Response to Request for
Further Information Item 10:
Response to Third Party
Submissions and Observations

COOM GREEN ENERGY PARK RESPONSE TO ITEM NO. 10 - THIRD PARTY SUBMISSIONS

ABP Reference ABP-308885

Prepared for: Coom Green Energy Park Limited

TITLE:	Proposed Site Layout, Drainage and Flood Zones		
PROJECT:	Coom Green Energy Park, Co. Cork		
FIGURE NO:	3.1		
CLIENT:	Coom Green Energy Park Ltd.		
SCALE:	1:40000	REVISION:	0
DATE:	06/09/2021	PAGE SIZE:	A3

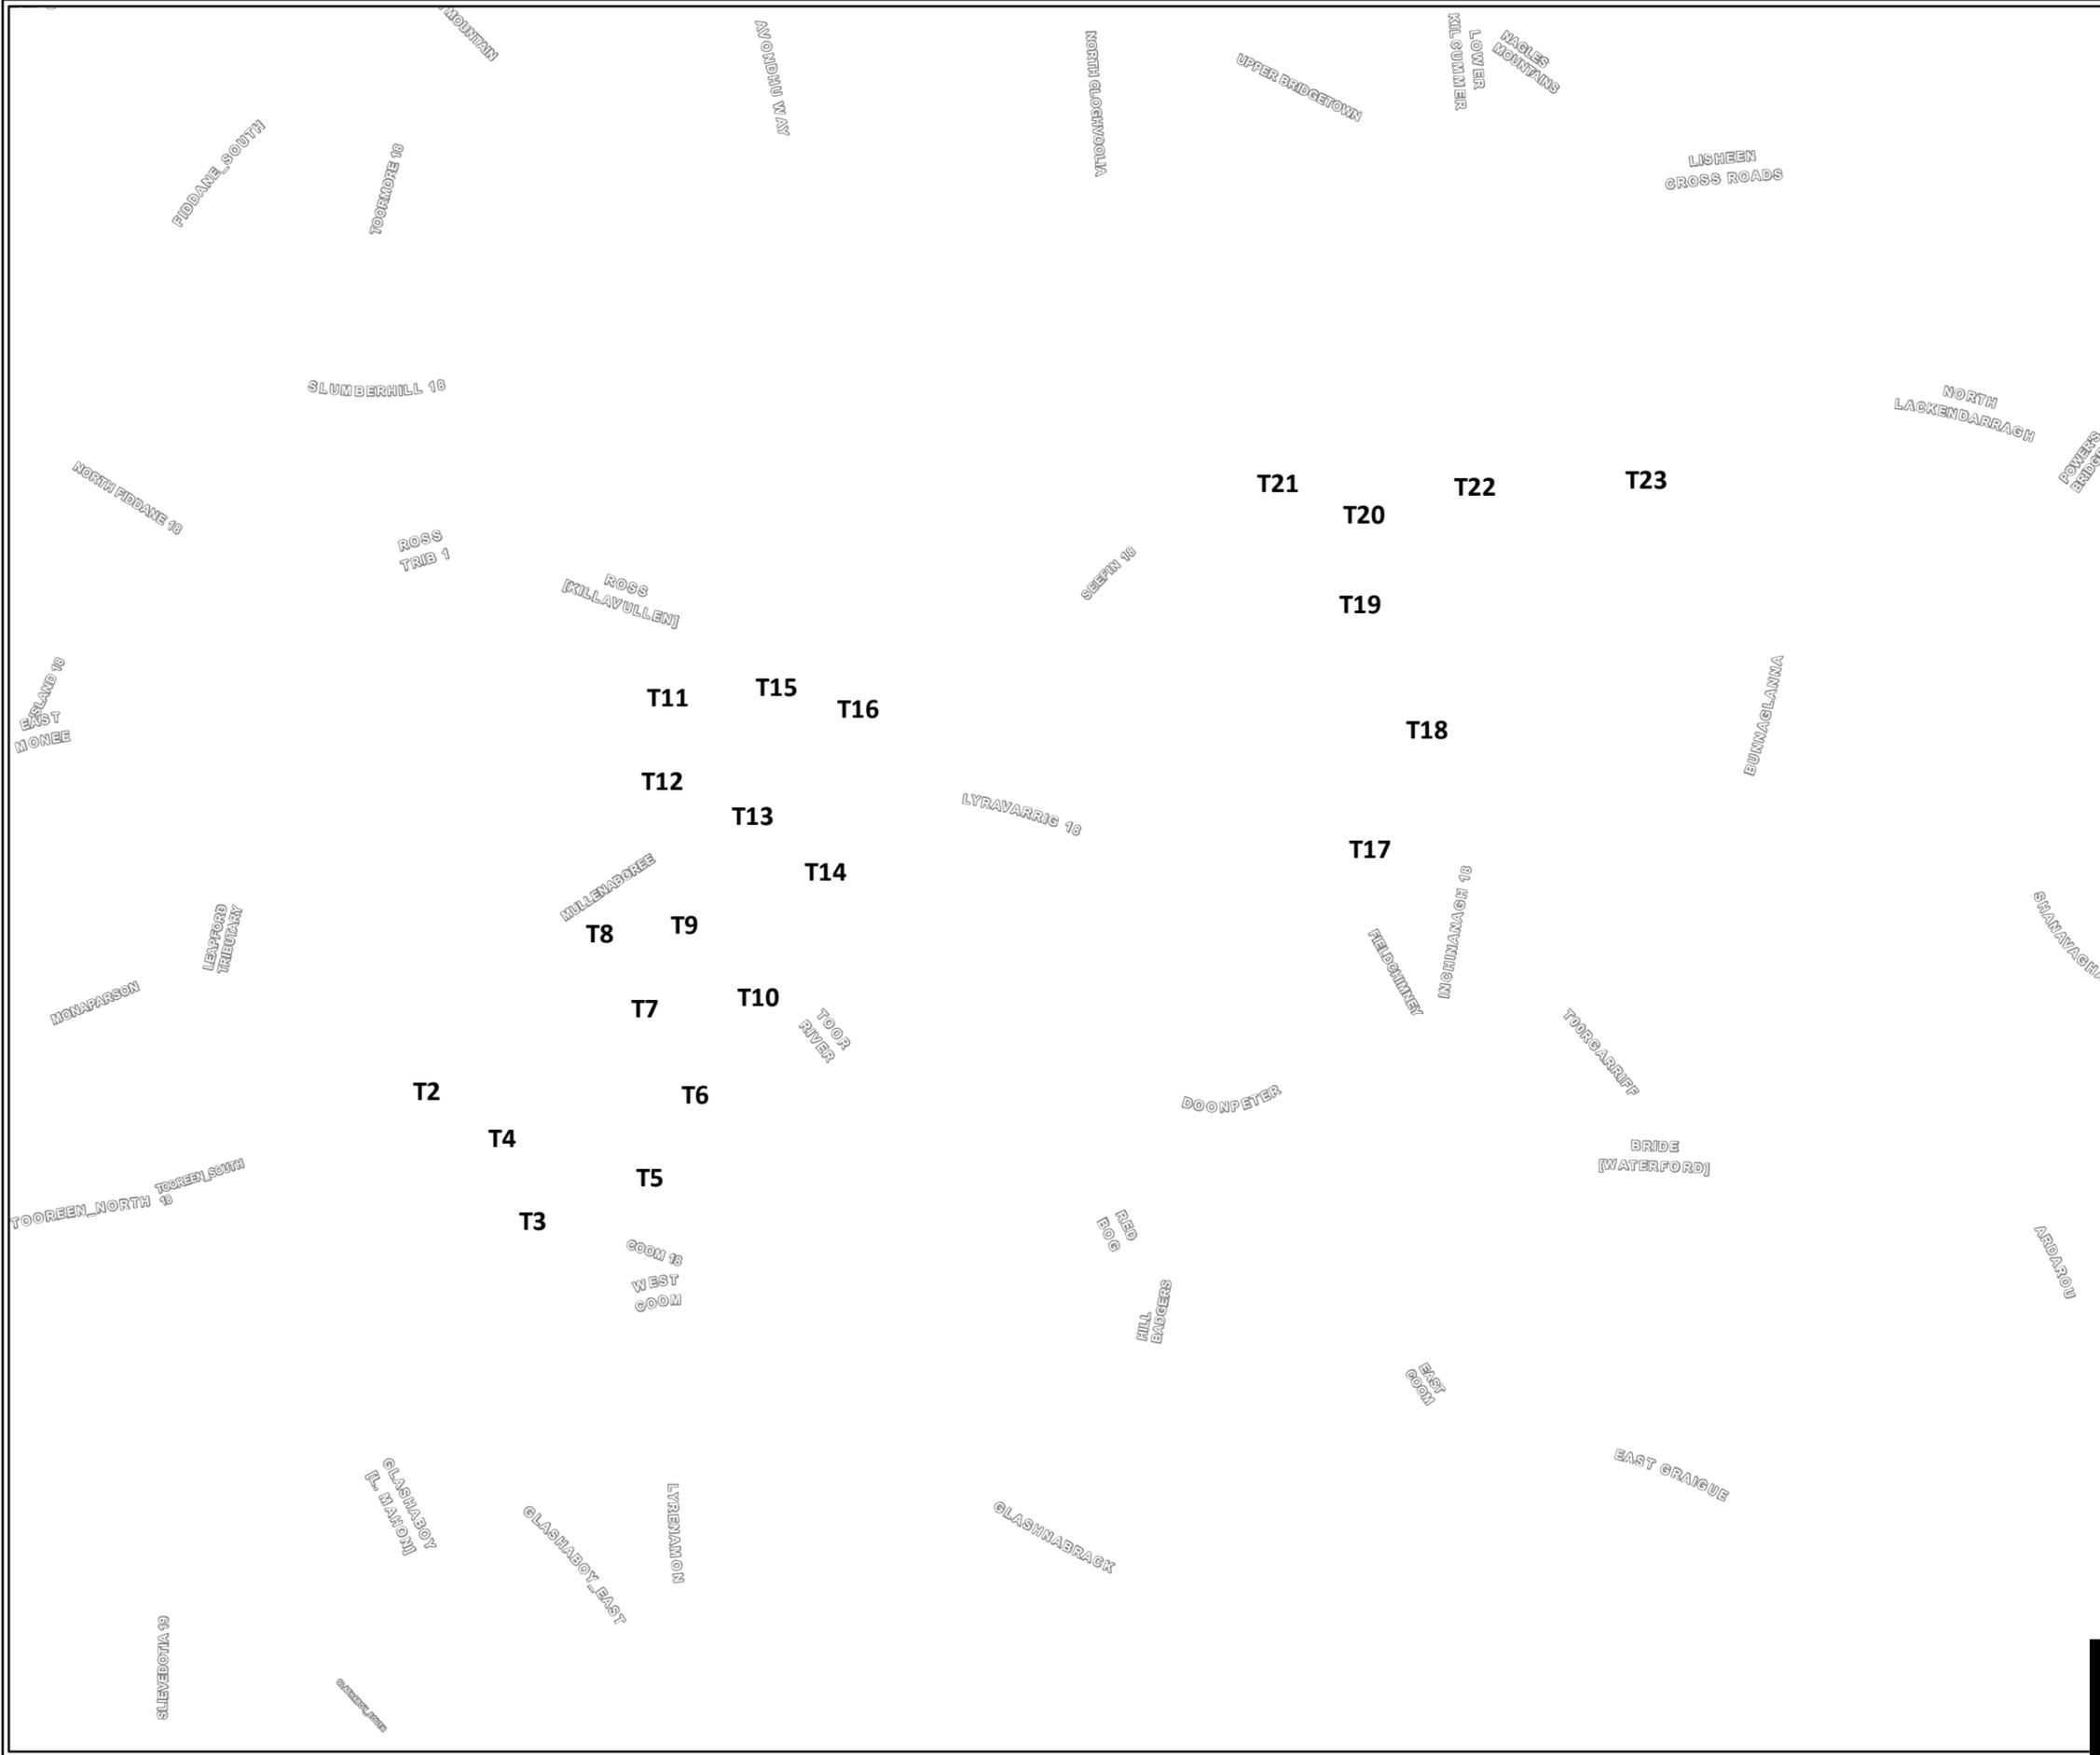
- No turbines or substations are located within Flood Zone A or B
- CCC is concerned that Turbines T3 and T5 are within a floodplain area. This is not the case, these turbines are at least 172m from the floodplain area. Please refer to Figure 3.1 below.

According to the LAP maps small part of the subject site is within Flood Zone A/B as shown on Figure 3.1 below. However, the proposed turbines and substations are located in Flood Zone C, in an area where the risk of flooding is low. Table 3.2 of The Planning System and Flood Risk Management defines appropriateness of a development in relation to the flood zone. According to this table, the proposed development is appropriate for this flood zone. Turbine T3 is 172m and T5 313m from the flood plain area as shown on Figure 1. The flood level for Flood Zone B is estimated to be 249mOD. The proposed turbine T3 is 257 moD and T5 is 260 mOD. The proposed turbines are at least 8m above flood levels.

Figure 3-2: Copy of Figure 13-7 from Chapter 13 of the EIAR

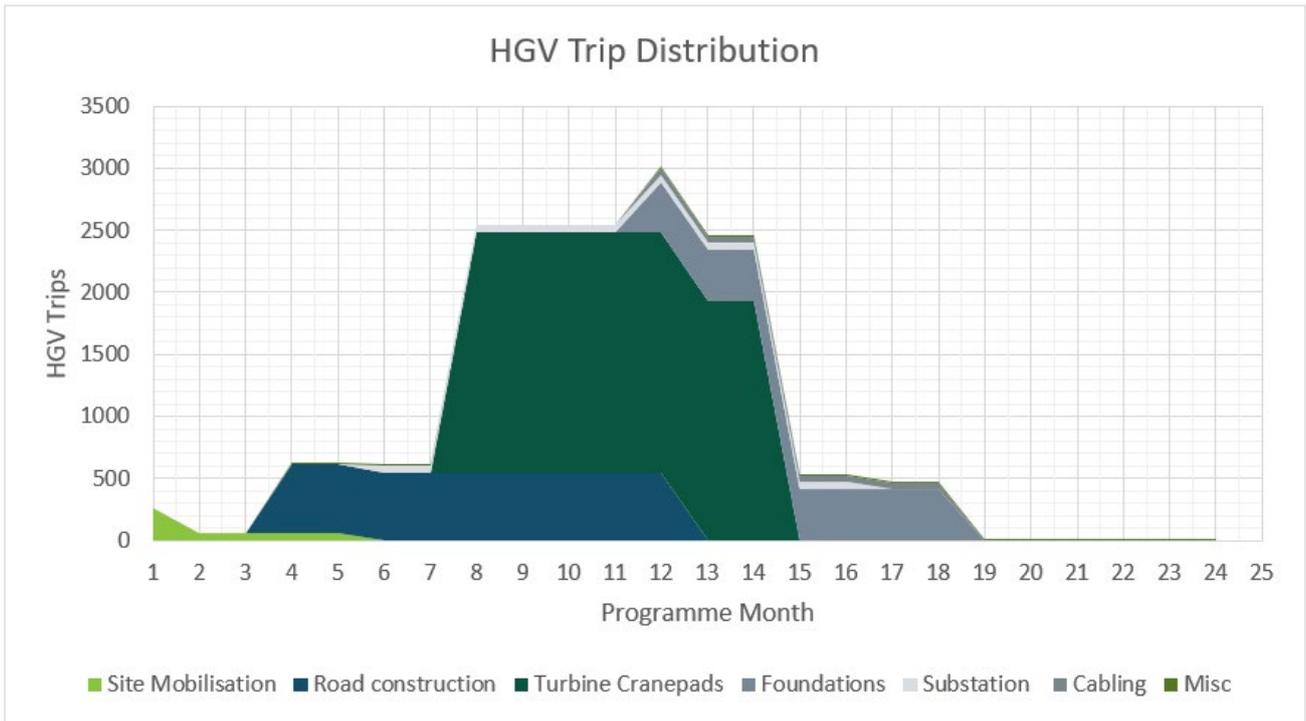
Figure 13-8 of the EIAR outlines that construction traffic amounts to 119 HGV average daily trips in months 8, 9, 10 & 11 with a peak of 140 HGV average daily trips in month 12. Details should be provided showing how these daily HGV trips have been calculated as the breakdown in Figure 13-7 is unclear.

Figure 13-7 presents HGV Trip Distribution for the project across the proposed construction programme, breaking out the total no. of HGV trips calculated for each key programme activity for each month. A copy of this figure is presented below.

Figure 4-1: RFI Viewpoint locations

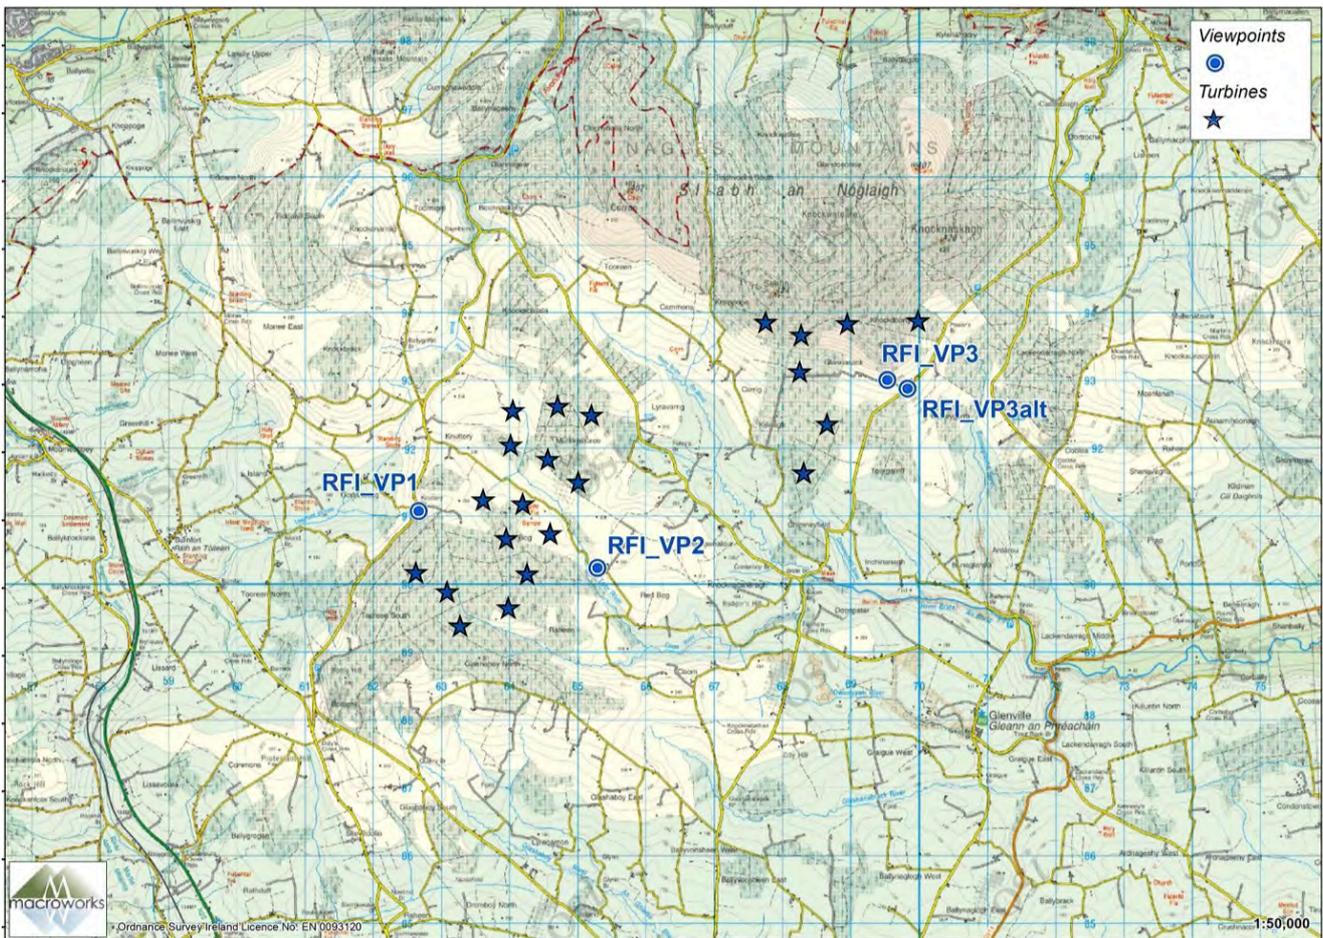
Receptors 83, 84 and 85: The nearest viewpoint provided in the EIAR is viewpoint 12, however this viewpoint is located downhill to the south of the dwellings and is obscured by tree planting. These receptors have turbines 20, 22 and 23 to the north, turbine 19 to the west and turbine 18 to the south west. There are concerns about the collective visual impact of this cluster of turbines on these receptors. To enable a full assessment of the visual impact on these receptors, additional visuals should be requested from the applicant with the viewpoint located close to these dwellings.

Receptors 36 & 37 were identified with respect to capture and assessment of an additional view and because these receptors were also picked up by An Bord Pleanála, the assessment of the relevant additional view (RFI2) is provided in response to the ABP submission in section 4.2.2 above. New views were also captured at the locations identified by Cork County Council and are assessed below. Receptors 83, 84 and 85 are represented by viewpoint RFI1 and receptor 9 is represented by RFI3.
